**ADDENDUM NO. 1**

Bid Name SW 40<sup>th</sup> Extension and SW 47<sup>th</sup> Ave Trail

Bid No.: WSPP-180086-DM

**ADDENDUM NO. 2**

**110-1 Description.**

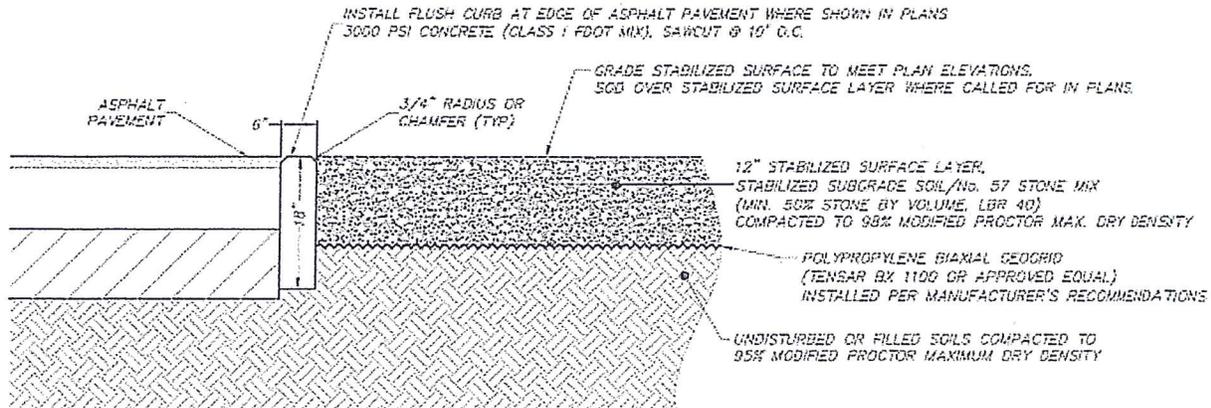
7. Question: What work is covered by the pay item, "Miscellaneous Demolition"? I did not see this covered in the specifications.

Answer: Please refer to FDOT Item # 0110 1 2. This item is described as follows:

Clear and grub within the areas shown in the Plans. Remove and dispose of all trees, stumps, roots and other such protruding objects, buildings, structures, appurtenances, existing flexible asphalt pavement, and other facilities necessary to prepare the area for the proposed construction. Remove and dispose of all product and debris not required to be salvaged or not required to complete the construction.

*INDEX OF ROADWAY PLANS*

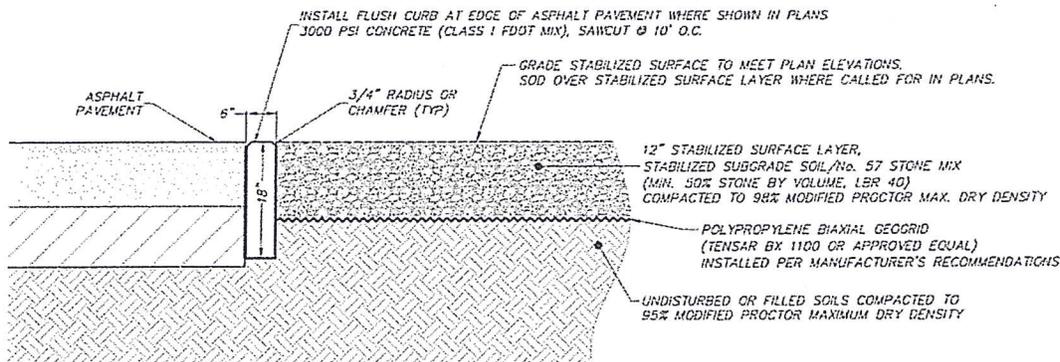
Question: Sht.#10 missing from plans

Answer: Correct. Please refer to the cover sheet of the SW 40<sup>th</sup> Boulevard Extension Project. This sheet was not used.

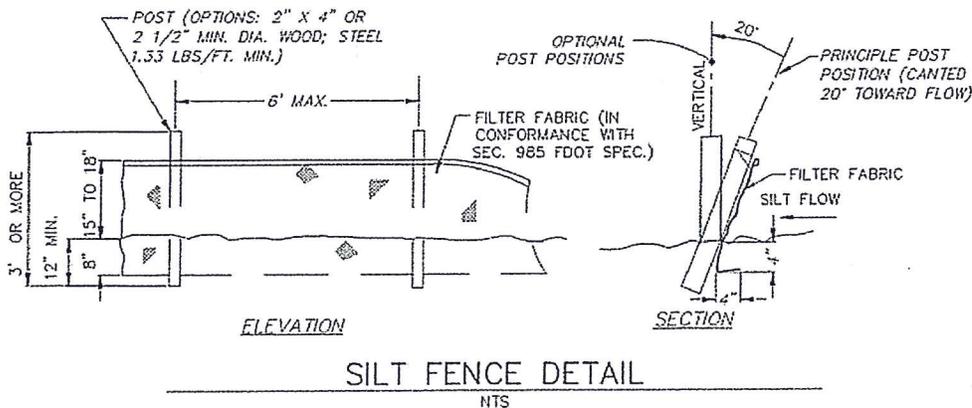
5. Question: Ribbon Curb is shown in pay items, but we cannot locate on plans.

Answer: Please see the Stabilized Path Detail on Sheet 11:

Ribbon Curb shall be provided at the edge of asphalt pavement when adjacent to the Stabilized Path. The curb and path location is shown on sheets 17, 18, 19, and 20
